**Tuesday January 28, 2020
Medway Planning and Economic Development Board
155 Village Street
Medway, MA 02053**

21 Trotter Drive /Marzilli Site Plan Endorsement:

Choate Trail Way Definitive Subdivision Plan and Scenic Road Work Permit:

SCENIC ROAD INTERSECTION PLAN

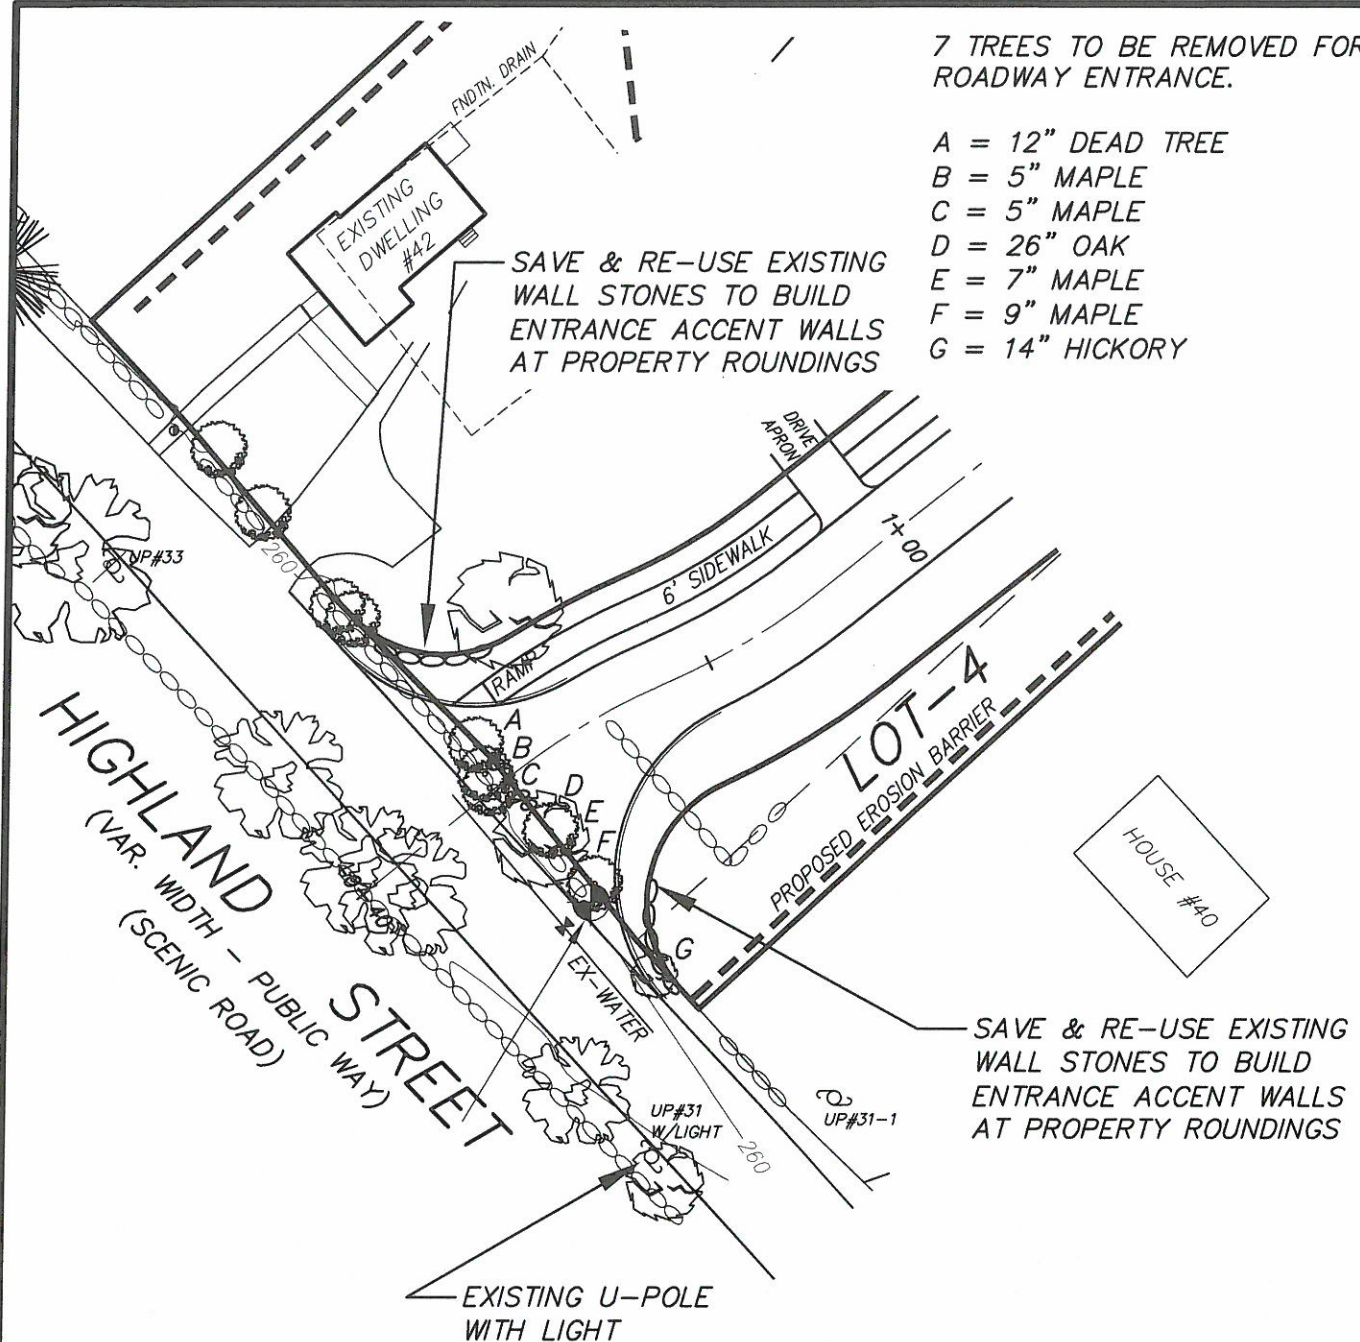
There are limited alternatives for the road location due to the existing wetlands on site. The proposed mitigation will be to reuse all stones removed from the existing walls to create stone wall roundings at either side of the proposed roadway entrance. The applicant is open to making a payment in lieu of on-site plantings.

Steve Carew, Park Superintendent and Tree Warden, was present to discuss his recommendation for the tree mitigation. His recommendation was for a payment in lieu of tree planting. There is a concern about planting this time of year. He is also concerned with the plant availability. He communicated that the site does not warrant the number of replacement trees that would be required per the formula included in the Scenic Road Rules and Regulations. He also indicated that there are no specific locations in town which need trees at this time. The trees which are coming down are four Maple trees which are not significant in size. These Maple trees have not been showing foliage and are showing signs of decline. There are also some dead trees which need to come down anyway. The site does not have the room for the recommended number of tree replacements. There could be the installation of other plantings but not trees. Mr. Carew will provide a written recommendation. Susy would like to see if there are locations around town which could use plantings. The Conservation Agent communicated that there could be some plantings added to wetland areas.
